MRP Materials Reliability Program _____ MRP 2015-025

SUBJECT: EPRI-MRP Interim Guidance for Management of Thermal Fatigue

NEI 03-08 Needed and Good Practice Interim Guidance for Management of Thermal Fatigue

Figure 1
Revised volumetric examination recommendations.

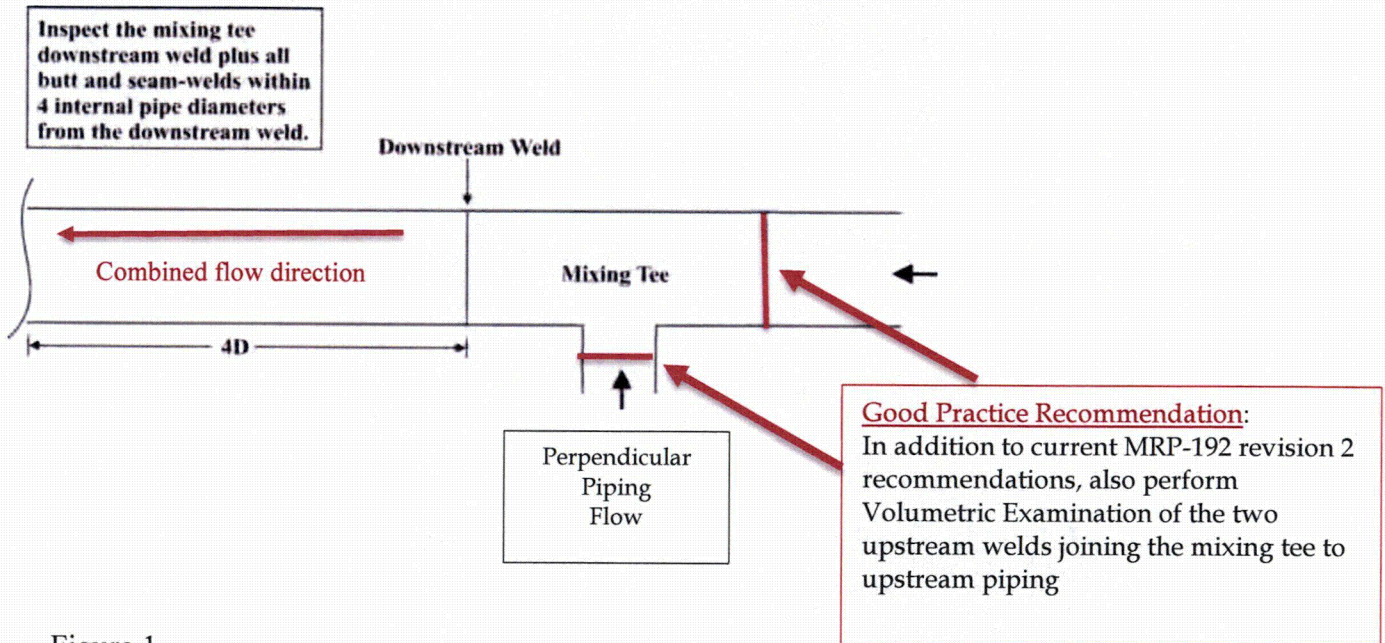
In addition to the examination volumes specified in Section 3 of MRP-192, Revision 2, it is recommended that future MRP-192 examinations also include the Mixing Tee weld to the upstream piping as shown in Figure 1.

Figure 2

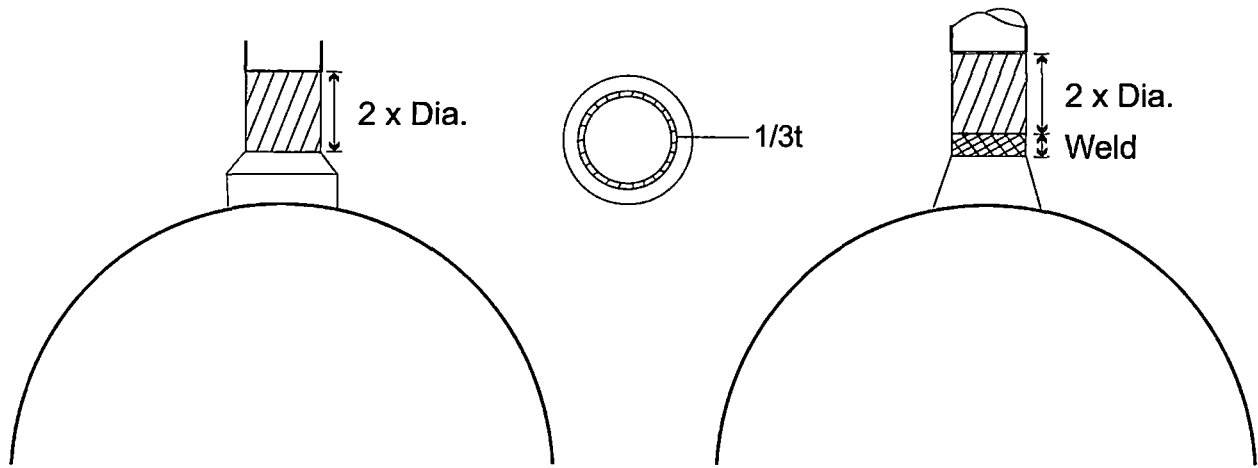
Normally stagnant UH piping, with nominal pipe sizes greater than 1-inch NPS and not larger than 2 -inches NPS and having a potential for cold in-leakage shall be examined every refueling outage commencing with the first refueling outage starting after June 1, 2016. Examinations shall conform to the requirements of MRP-146 as augmented in this Interim Guidance letter. The examination volume shall include the areas described in Section 2.4.2.1 of MRP-146, the pipe to nozzle (butt) weld and the vertical pipe base metal up to two pipe diameters above the weld or to the elbow if it is less than 2D from the weld as shown in figure 2. Examination of socket welds is not required.

Up-Horizontal (UH) normally stagnant piping with nominal pipe sizes (NPS) of between 2 and 4 inches and having the potential for cold in-leakage, shall be examined using the examination requirements of MRP-146 as augmented in this Interim Guidance letter. This one-time examination shall include the pipe to nozzle (butt) weld, and the vertical pipe base metal up to 2 pipe diameters above the weld or to the elbow if it is less than 2D from the weld as shown in figure 2. Examination of socket welds is not required.

Detailed view of the additional examination volume for Up Horizontal configured branch lines between 1 and 4 inches NPS that also have potential for in-leakage.
